REPLY UNDER 37 CFR §1.116
EXPEDITED PROCEDURE
TECHNOLOGY CENTER 2800

In re application of:	§	Attorney Docket No. 2003-0893 /
Chen-Bau Wu, et al	§	24061.148
.	§	
Serial No.: 10/821,432	§	Customer No. 42717
	§	
Filed: April 9, 2004	§	Group Art Unit: 2815
	§	
For: A High Voltage Semiconductor	§	Examiner: Budd, Paul A.
Device Utilizing A Deep Trench	§	
Structure	§	Conf. No. 1237

AMENDMENT AFTER FINAL

UTILIZE DEEP TRENCH STRUCTURE TO PREVENT LDMOS FROM PARASITIC TURNING-ON CHANNELS

Fig. 2

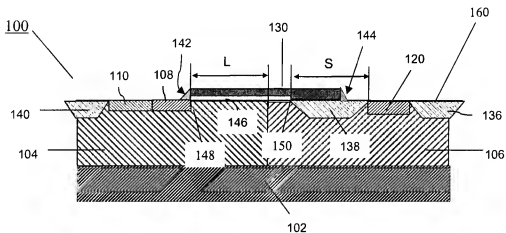
Applicant has corrected the title of each of the drawings and amended Figures 2 and 3. Replacement Sheets are attached.

The title of each of the drawings has been corrected per the Examiner's suggestion. Figures 2 and 3 have been resubmitted with hatching per the Examiner's suggestion. Additionally, in Figure 3, reference numeral "140" has been amended to "142," reference numeral "142" has been amended to "144," and reference numeral "144" has been amended to "146." Figure 3 has been amended to be consistent with Figure 2 and the description in the Specification. No new matter has been added.
